COUNCIL ASSESSMENT REPORT

Panel Reference	2017SWC148
DA Number	984/2018/JP
LGA	The Hills Shire Council
Proposed Development	Demolition of existing structures, subdivision of land, construction and strata subdivision of a multi dwelling housing development comprising 110 town houses, temporary drainage basin, public road and private road.
Street Address	Lot 89, 90A and 90 DP 11104 and Lot 92 DP 10157, Nos. 39, 41 and 43 Hynds Road, Box Hill
Applicant/Owner	Eden Investment Group Pty Ltd C/- Craig and Rhodes Pty Ltd Fortune Land Holdings Pty Ltd
Consultants	Project Manager and Town Planning: Craig and Rhodes Pty Ltd Architect: Rothe Lowman Landscape Architect: Arcadia Engineering: Craig & Rhodes Surveyor: Craig & Rhodes Arborist: Naturally Trees Arboricultural Consulting Aboriginal Heritage: Niche Environment and Heritage Accessibility: ABE Consulting BASIX: Wood and Grieve Engineers Geotechnical: Network Geotechnics Waste: Waste Audit and Consultancy Services Quantity Surveyor: MBMpl Pty Ltd Environmental Health: GeoEnviro Consultancy Pty Ltd Traffic: PTC Consultants

consideration	
Report prepared by	KATE CLINTON SENIOR TOWN PLANNER
Report date	20 JUNE 2019

a. Indicative Layout Plan and Land Development

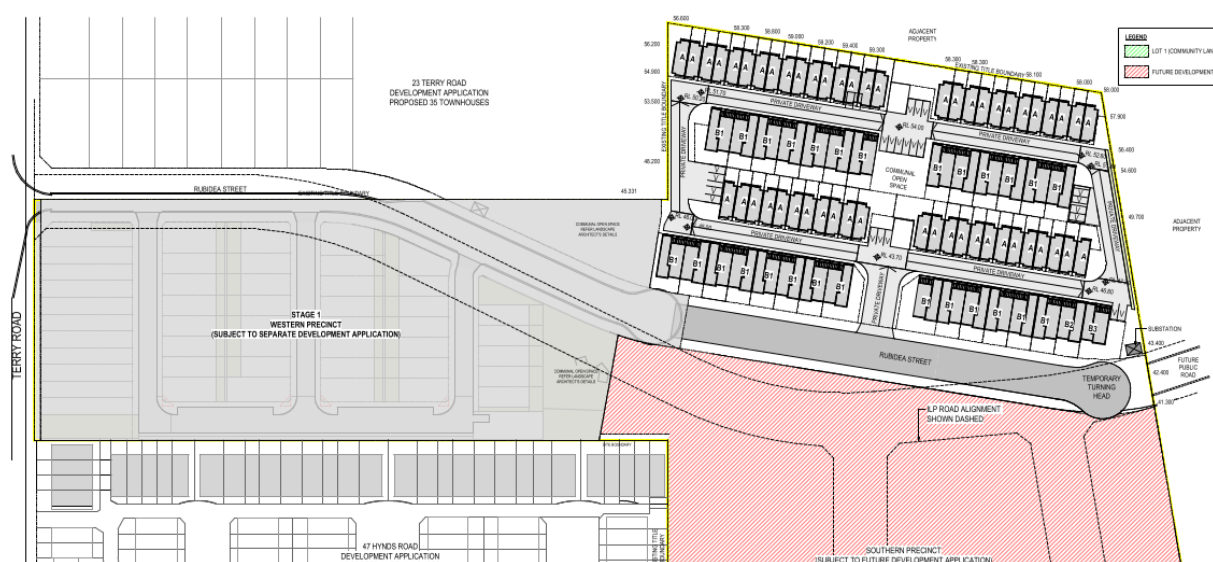
The realignment of Rubidea Street proposed in this application is solely confined to the subject site and the site of the related Stage 3 development application to the south. The further amendment to the Indicative Layout Plan (ILP) and street network is considered acceptable as:

- It will not adversely impact on traffic flows; and
- It will not adversely impact on the orderly development of adjoining properties since the proposed alignment of Rubidea Street realigns with the Indicative Layout Plan as it connects with adjoining land at No. 37 Hynds Road.

b. Cut and Fill

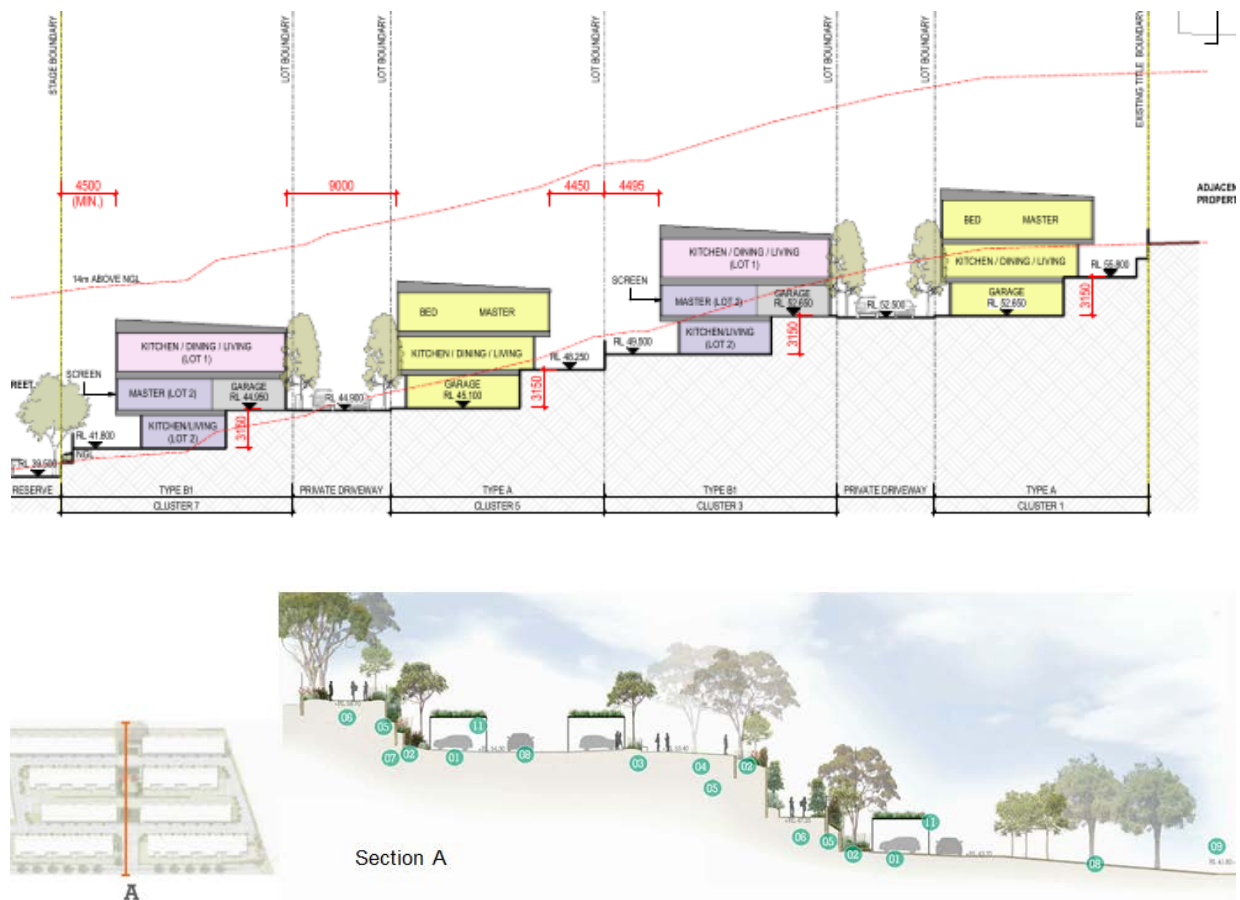
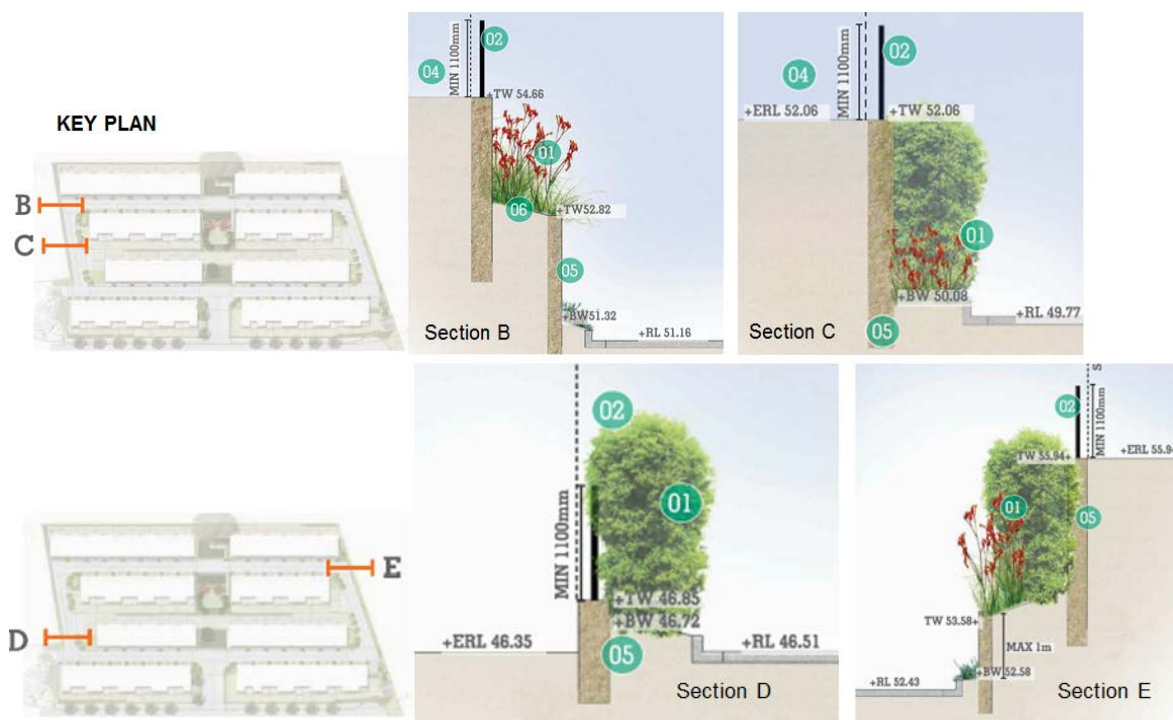
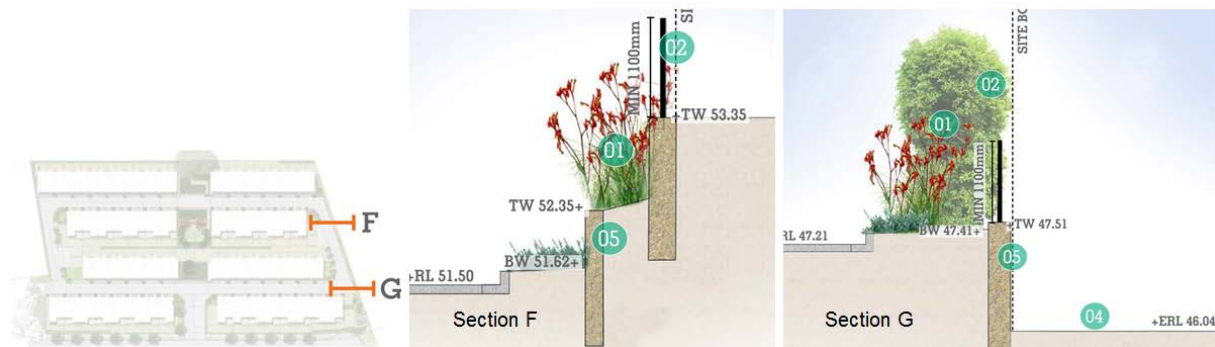
The proposed retaining walls and associated cut and fill are a result of the significant slope of the site and the need to provide a balance of cut and fill at the front and rear of the site. Levels have also been dictated by the gradients required for the internal road to allow for waste collection and other service / removalist vehicles to access the site. Waste collection from a single point on the frontage of Rubidea Street was deemed to be impractical and unacceptable since travel distances and gradients would not allow residents to safely dispose of individual bins to one bin collection point at the lowest part of the site. A 5m retaining wall presenting to Rubidea Street on the western frontage of the site was also considered to be unacceptable and was therefore requested to be reduced.

As illustrated in the Landscape Plan (refer Attachment No. 16), the majority of retaining walls are tiered and are proposed to incorporate substantial landscaping.

Although proposing some areas of significant cut in the northeast, northwest and central area of the site, overall the site offers a reasonable transition to the surrounding land in terms of the cut and fill proposed. Since the change in landform involves cut, there will be no impacts on the amenity of the adjoining lands in terms of privacy or solar access. Furthermore, the most significant cut proposed within the site is generally located to the side of the proposed dwellings in the north east and north western corners, thereby reducing the impact on future residents of the development, with the exception of those in the centre of the site on either side of the lower bin storage area which have also been provided with larger private open space areas.

LANDSCAPE MASTERPLAN

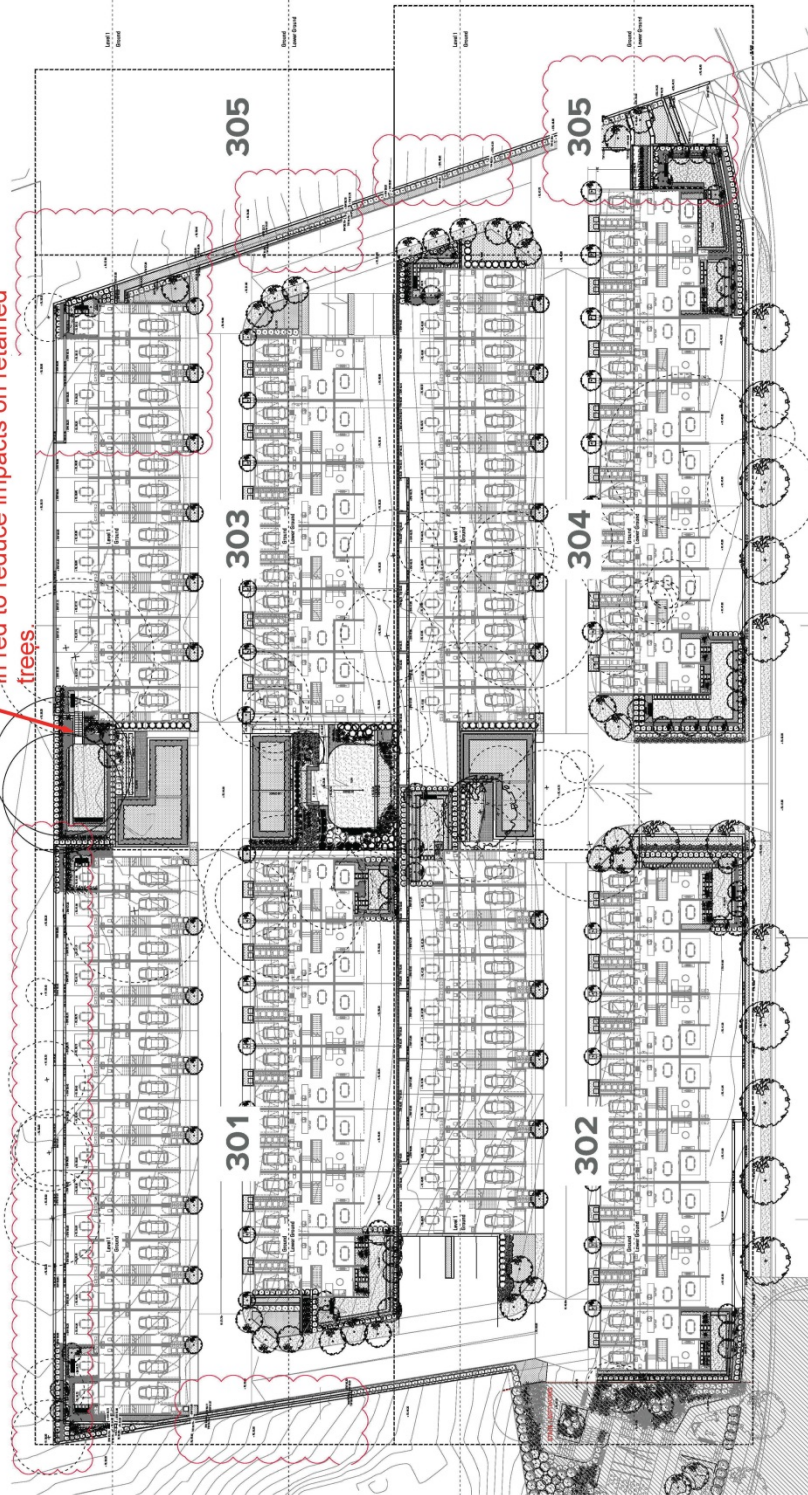
Levels, stairs and retaining wall
location and design to match
Landscape Plan No. 303 as marked
in red to reduce impacts on retained
trees.
